**CITY OF PORTLAND, MAINE
DEVELOPMENT REVIEW APPLICATION
PLANNING DEPARTMENT PROCESSING FORM
Planning Copy**

Unifirst Expansion
Project Name/Description

430 - 430 Riverside Ind Pkwy, Portland, Maine
Address of Proposed Site
354 B002001
Assessor's Reference: Chart-Block-Lot

Re: Unifirst Expansion – Final Plans
Application # 2006-0151

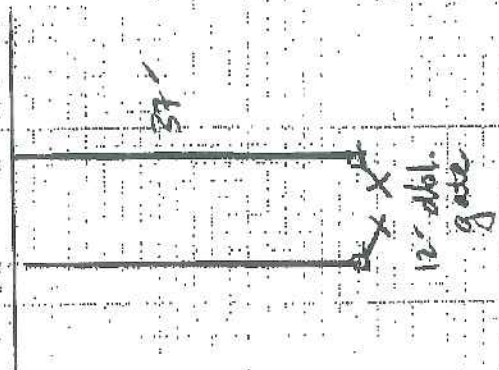
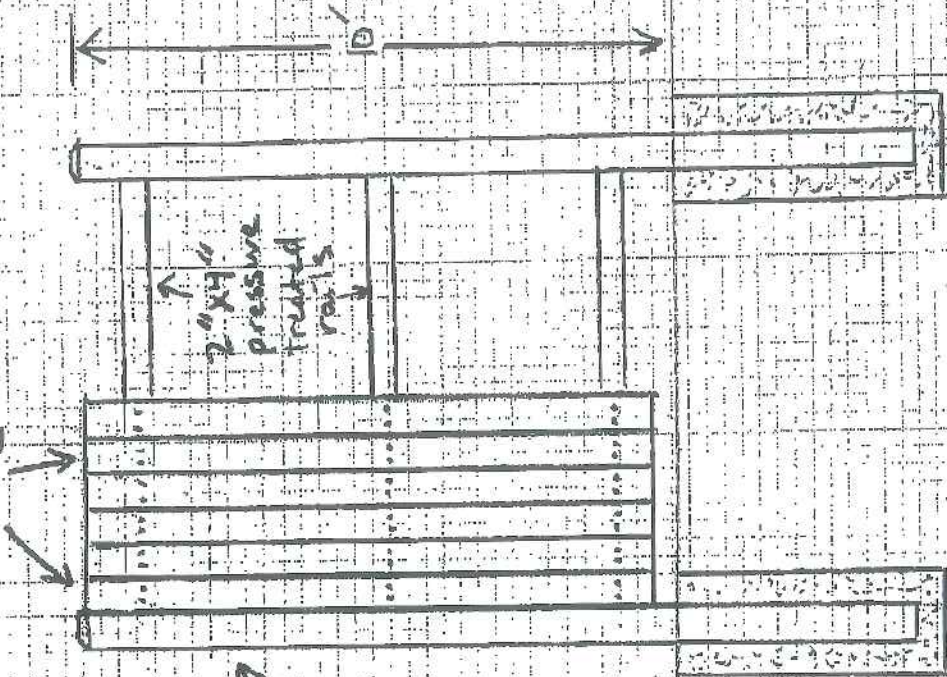
Finally, I have a trash compactor gate detail for UniFirst. Please let me know if this looks acceptable.

Chainlink with privacy slats is a non-starter with the city. Get me a
detail of the wood option and I will forward to the city.

revised trash enclosure re cond. OK JF 1-2-07.

I confirm that the City Planning Division has approved the proposed fencing and gate details as shown in the the two attached sketches and also confirm that the Condition i of the Approval letter dated October 24, 2006 has been complied with.

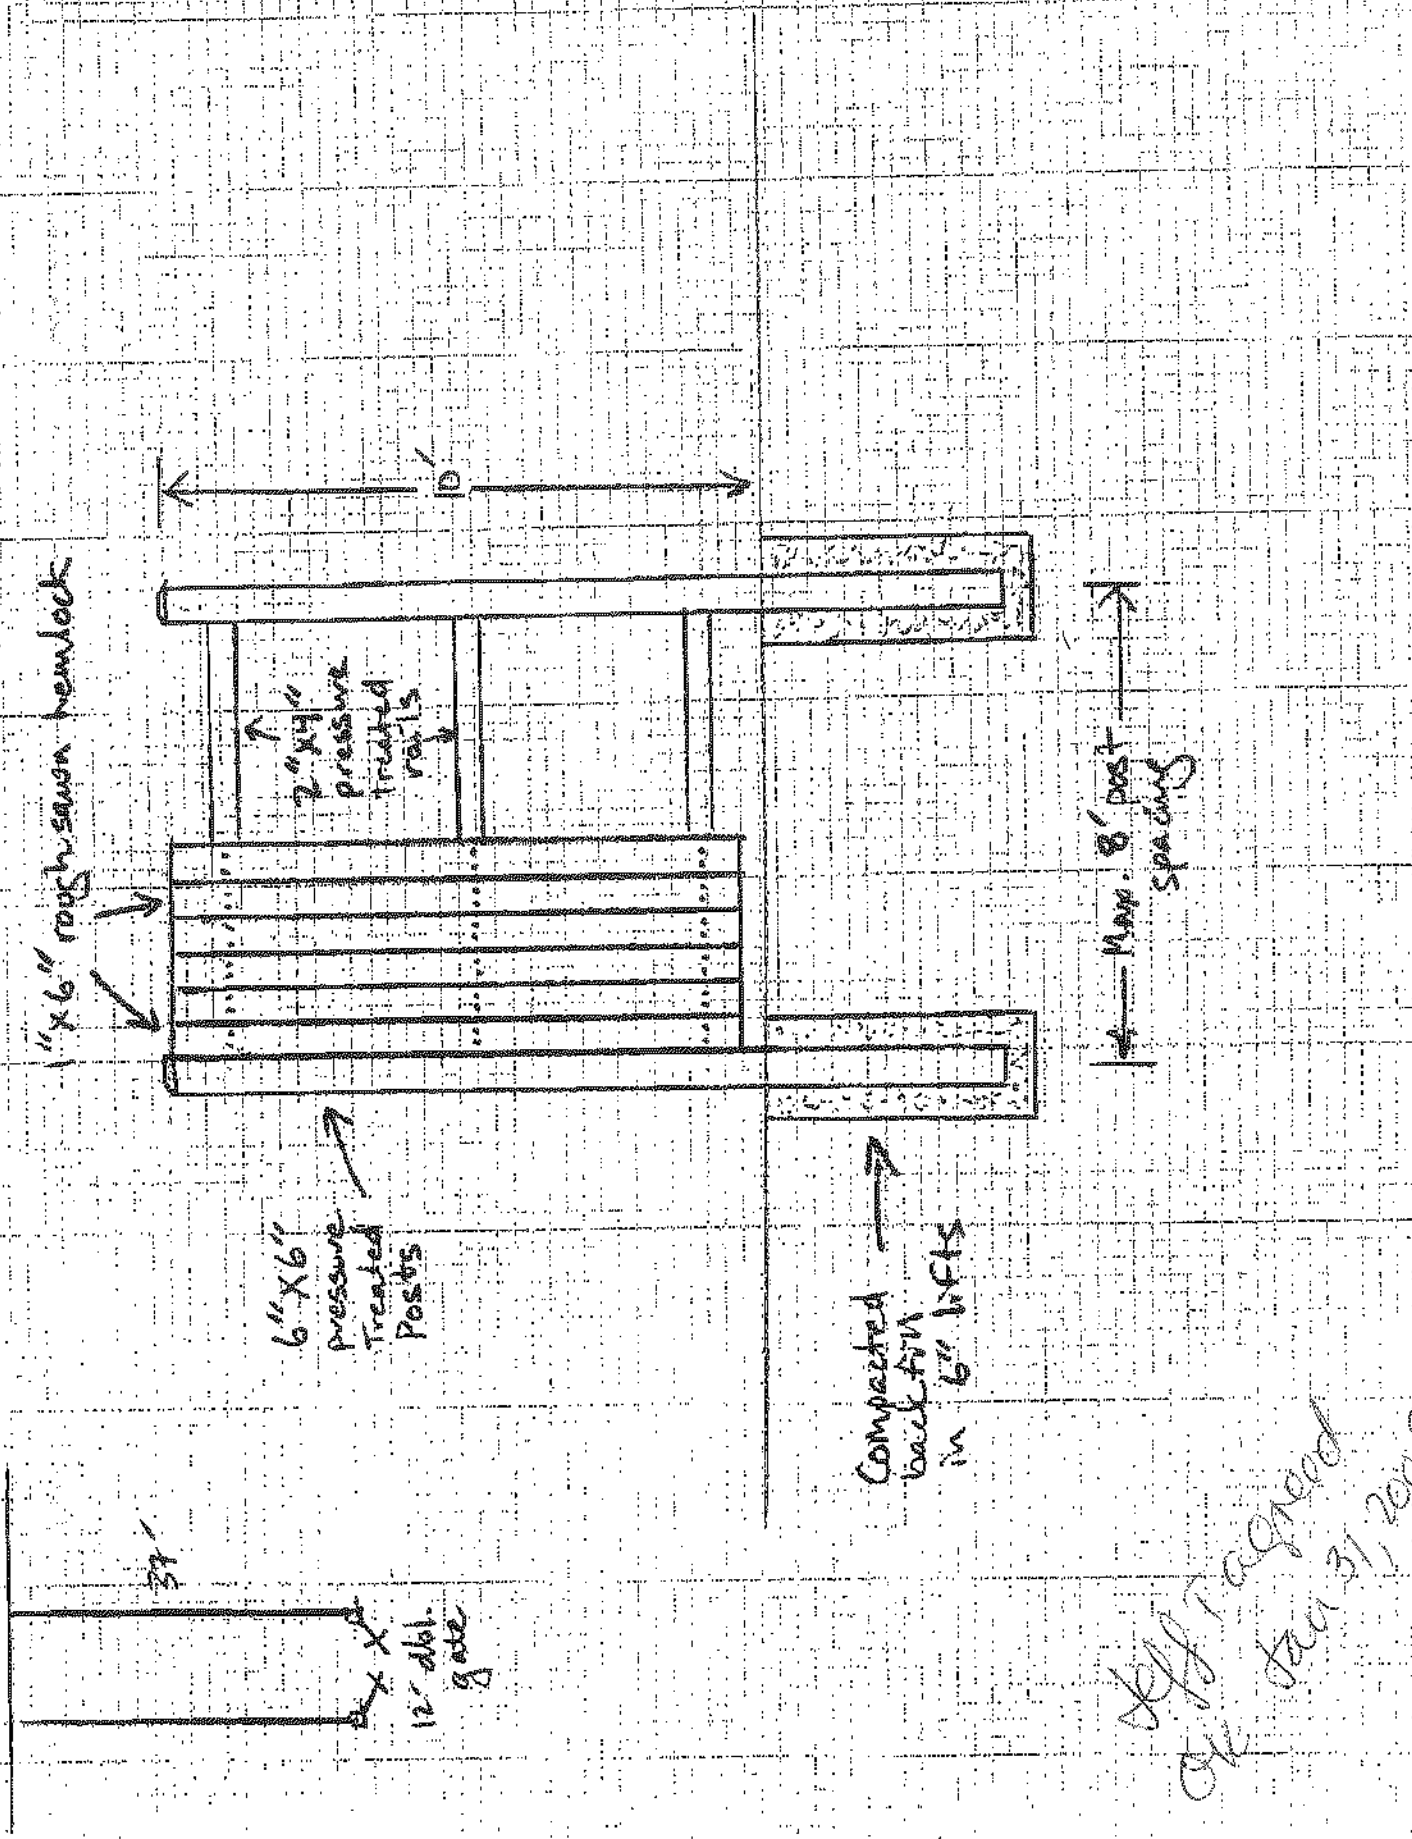
Attached is a sketch of the proposed wood dumpster fence enclosure. Let me know on this after your hear from the city.

The gate faces the street and therefore could you please send a drawing of that too.

VINYL STOCKADE PRIVACY FENCE
FOR COMPACTOR ENCLOSURE
COLOR: WHITE

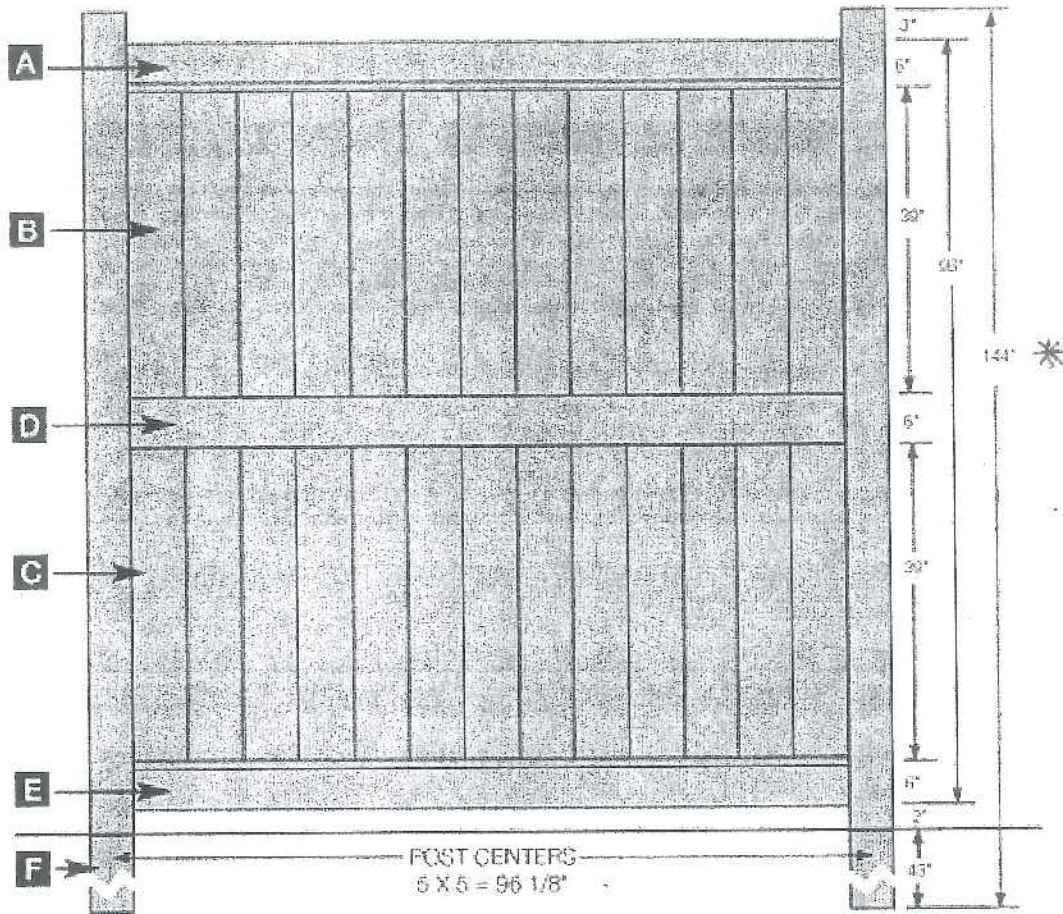
* 8 feet high / 8 feet wide

* Posts will be lengthened to provide room for 2" skirting around bottom of fence. Total fence height will be 10 feet.

Response: We have added a 10 foot high vinyl fence around the trash compactor and attached a catalog cut for the proposed vinyl fence. Note that the catalog cut only shows an 8 foot high fence. The applicant is proposing to install the fence on longer poles and provide a vinyl skirting material around the base to provide the 10 foot height. The posts will be reinforced with steel poles for additional strength. Specific notes regarding the trees to remain have been added to the Landscape Plan as requested. We have included 7 sets of revised plans and a compact disk with digital files of the plans as requested.
